Fuels Safety Program	Ref. No.: FS – 140 - 08	Rev. No.:
ADVISORY	Date: November 24, 2008	Date:

Subject: Wolf Steel Ltd.– Propane-Fired Direct Vent Fireplace Inserts
Models: GDI-44 & CDI-44 Series

UPGRADE KIT GDI-44P

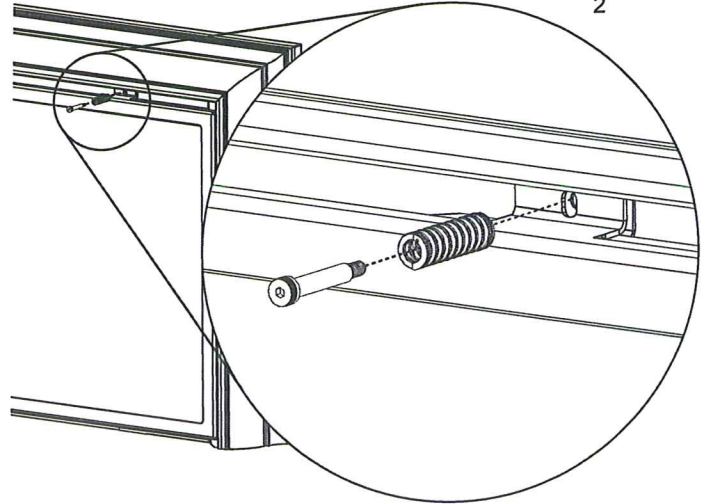
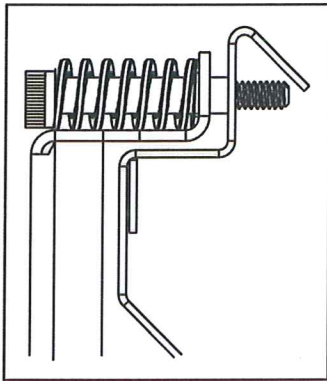
Wolf Steel Ltd. has determined that, under abnormal conditions, the GDI44 propane model insert maybe unable to withstand the pressure created from the ignition of an accumulated amount of propane gas. This may result in the shattering of the glass window, which presents the risk of burns or cuts from the broken glass.

As an added safety feature, these components have been incorporated into the design of the fireplace. Please retain these instructions with your manual for future reference when cleaning the glass.

PART #	DESCRIPTION	QTY
W570-0136	SHOULDER SCREW	2
W630-0017	SPRING	2

1. Remove the two #10-24 screws from the top of the door and discard.
2. Re-secure the door by screwing the shoulder screws through the springs as illustrated. Tighten using a 1/8" hex key.
